Response to Referee #2

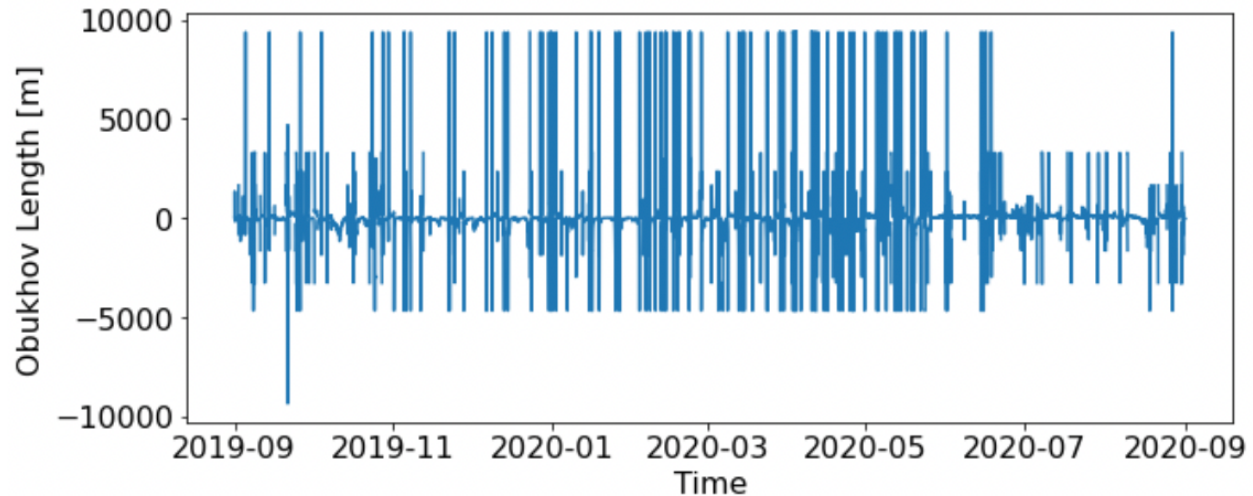
- Line 383 - 398: It seems a bit counter-intuitively that losses are not additive, i.e. internal losses + external losses \neq total losses. While the proposed loss estimates (9) and (10) do make sense, they do not share the same reference (P_VW_only vs P_NWF), which makes it more difficult to compare.

The total wake losses are not additive between internal and external losses, primarily because of nonlinear interactions but also because the denominators are different. We have added an alternative method for calculating external losses, represented as the subtraction between total and internal losses, which share the same denominator in new equation (12).
